SAN ONOFRE NUCLEAR GENERATING STATION, UNIT 2
AMENDMENT TO FACILITY OPERATING LICENSE

Amendment No. 28
License No. NPF-10

ATTACHMENT TO LICENSE AMENDMENT NO. 28FACILITY OPERATING LICENSE NO. NPF-10DOCKET NO. 50-361

Amendment No. 17
License no. NPF-15

Figure 3.1-1
 MINIMUM BORIC ACID STORAGE TANK VOLUME AND TEMPERATURE
 AS A FUNCTION OF STORED BORIC ACID CONCENTRATION

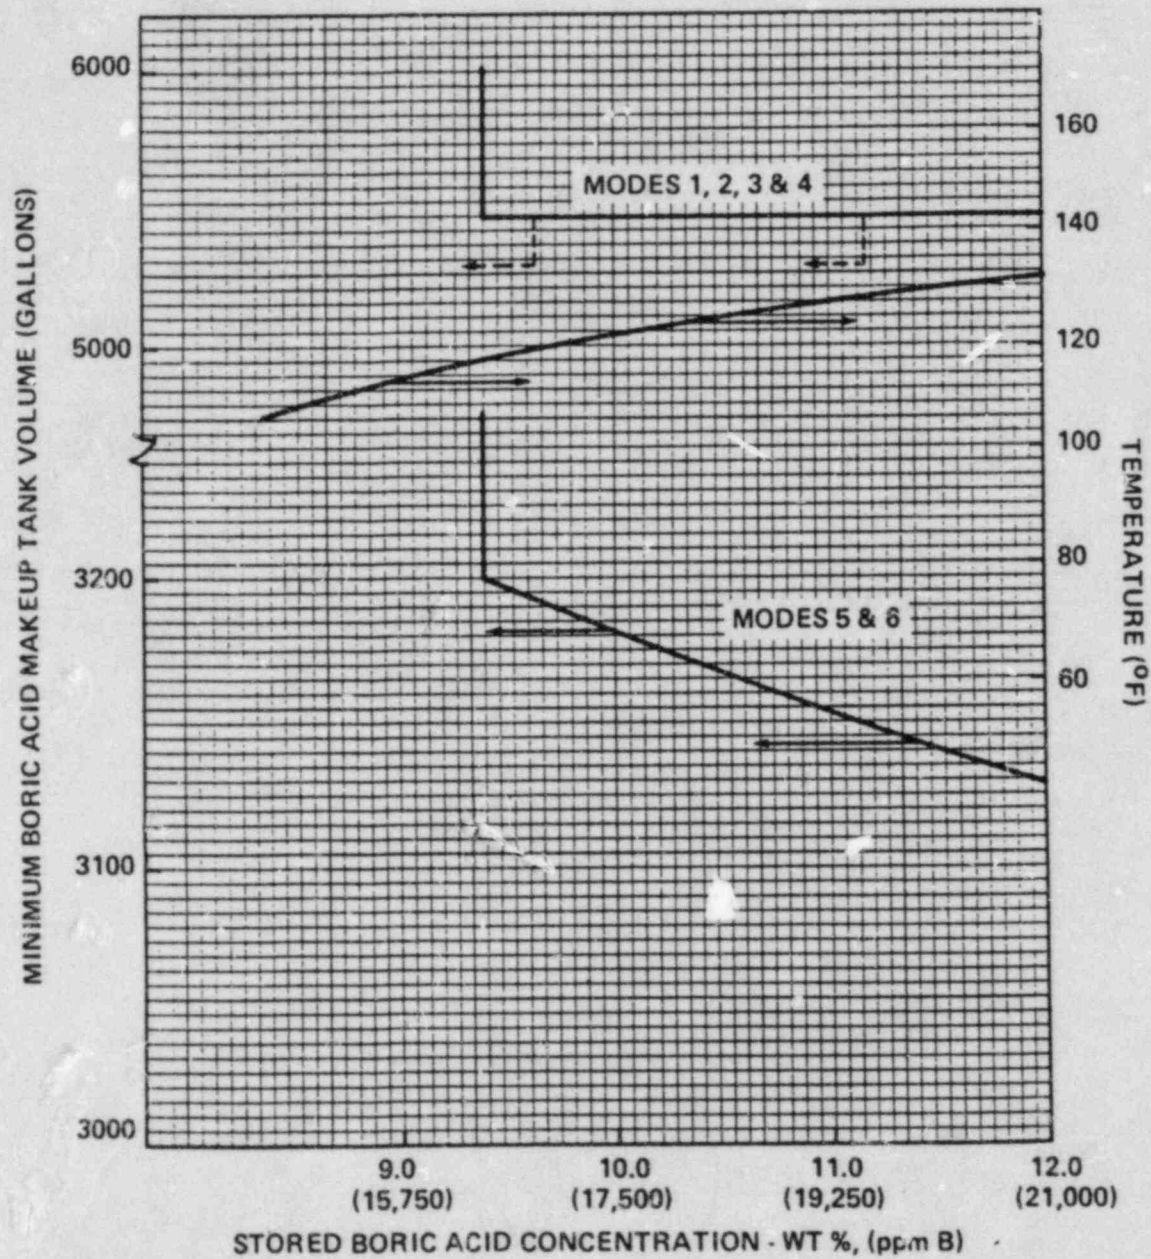
- a. At least once per 7 days by verifying that the temperature of the heat traced portion of the flow path from the boric acid makeup tanks is above the temperature limit line shown on Figure 3.1-1.
- b. At least once per 31 days by verifying that each valve (manual, power operated or automatic) in the flow path that is not locked, sealed, or otherwise secured in position, is in its correct position.
- c. At least once per 18 months during shutdown by verifying that each automatic valve in the flow path actuates to its correct position on a SIAS test signal.
- d. At least once per 18 months by verifying that the flow path required by Specification 3.1.2.2.a delivers at least 40 gpm to the Reactor Coolant System.

- a. One boric acid makeup tank and at least one associated heat tracing circuit with the tank contents in accordance with Figure 3.1-1.
- b. The refueling water storage tanks with:
 1. A minimum borated water volume of 9970 gallons above the ECCS suction connection,
 2. A minimum boron concentration of 1720 μ , and
 3. A solution temperature between 40°F and 100°F.

- a. At least one boric acid makeup tank and at least one associated heat tracing circuit with the contents of the tanks in accordance with Figure 3.1-1, and
- b. The refueling water storage tank with:
 1. A minimum contained borated water volume of 362,800 gallons above the ECCS suction connection,
 2. Between 1720 and 2300 ppm of boron, and
 3. A solution temperature between 40°F and 100°F.

Figure 3.1-1

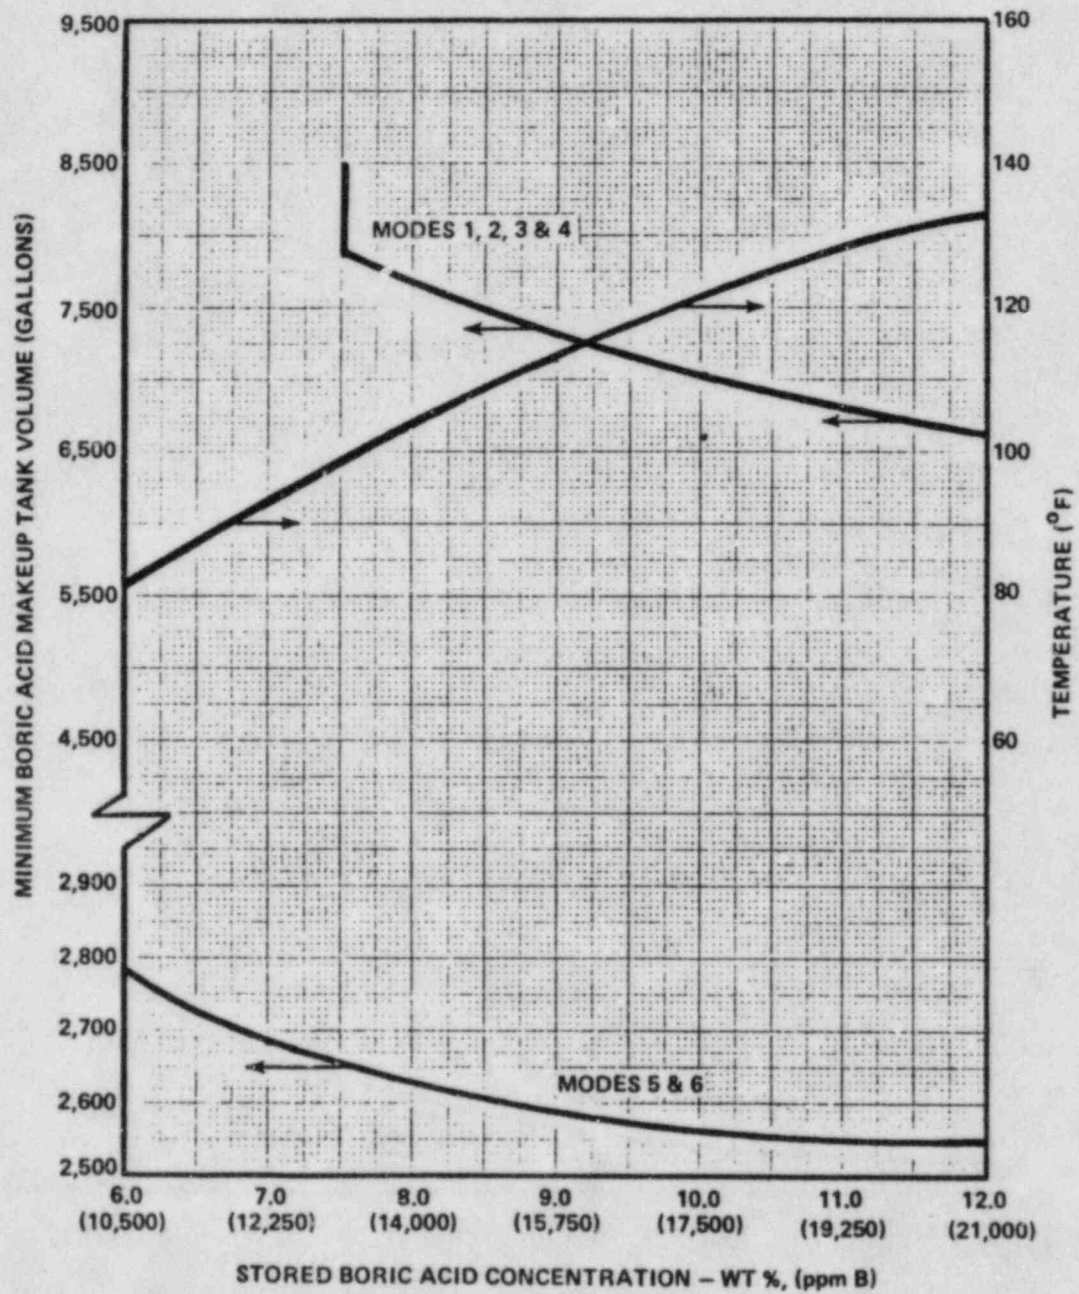
- a. At least once per 7 days by verifying that the temperature of the heat traced portion of the flow path from the boric acid makeup tanks is above the temperature limit line shown on Figure 3.1-1.
- b. At least once per 31 days by verifying that each valve (manual, power operated or automatic) in the flow path that is not locked, sealed, or otherwise secured in position, is in its correct position.
- c. At least once per 18 months during shutdown by verifying that each automatic valve in the flow path actuates to its correct position on a SIAS test signal.
- d. At least once per 18 months by verifying that the flow path required by Specification 3.1.2.2.a delivers at least 40 gpm to the Reactor Coolant System.

- a. One boric acid makeup tank and at least one associated heat tracing circuit with the tank contents in accordance with Figure 3.1-1.
- b. The refueling water storage tanks with:
 1. A minimum borated water volume of 5465 gallons above the ECCS suction connection,
 2. A minimum boron concentration of 1720 ppm, and
 3. A solution temperature between 40°F and 100°F.

- a. At least one boric acid makeup tank and at least one associated heat tracing circuit with the contents of the tanks in accordance with Figure 3.1-1, and
- b. The refueling water storage tank with:
 1. A minimum contained borated water volume of 362,800 gallons above the ECCS suction connection,
 2. Between 1720 and 2300 ppm of boron, and
 3. A solution temperature between 40°F and 100°F.
